ATC Site: 36075 – Lee s Summit #1B, MO (2200 Lowenstein, Lees Summit, MO, 64081)

Subject: Review of Tower Inspection and Summary of Remediation

480 FT GUYED TOWER MODIFICATIONS

NORTHEAST TOWER LEG
EL: 120'-0"

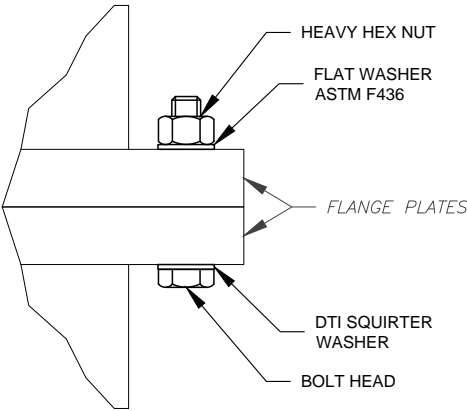
- 120' Leg A Loose Bolt Unable to Turn, could not tighten on site

This was corrected per ATC Project 12141861_N3_01, dated September 6, 2017.

REPLACE (1) SEIZED 5/8"Ø FLANGE BOLT WITH NEW 5/8"Ø X 2 3/4" A325 BOLT W/ NUT-FW & DTI SQUIRTER WASHER EA. [CONTRACTOR TO FIELD VERIFY BOLT SIZE AND LENGTH. SEE FIELD NOTE FOR SPECIFICATIONS.]

GUY WIRE RETENSIONING
AND STANDARD SAFETY
WIRE DETAILS

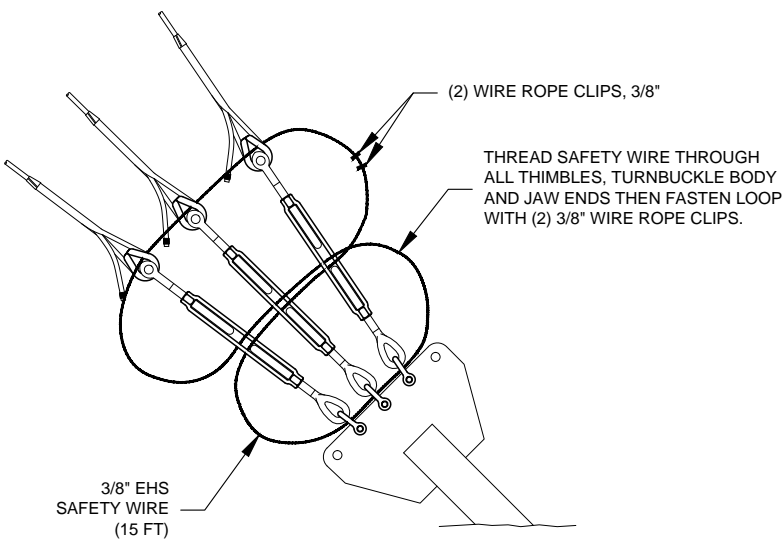
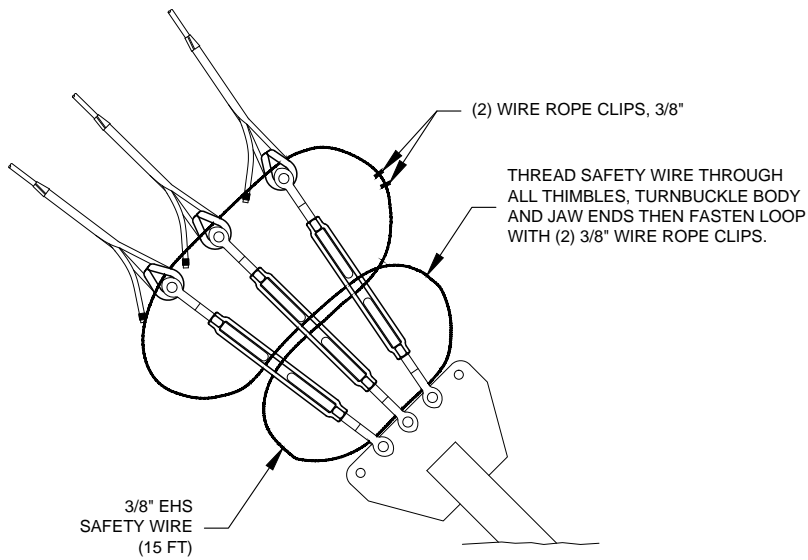
- Anchor A, AA, C Safety Wire Improperly Ran with Single Crosby Clamp

- Anchor B Safety Wire Improperly Ran with Single Crosby Clamp

- Anchor BB Safety Wire with Single Crosby Clamp

This was corrected per ATC Project 12141861_N3_01, dated September 6, 2017.

This was corrected per ATC Project 12141861_N3_01, dated September 6, 2017.

This was corrected per ATC Project 12141861_N3_01, dated September 6, 2017.

TYPICAL SAFETY WIRE INSTALLATION
DETAIL W/ SHACKLES
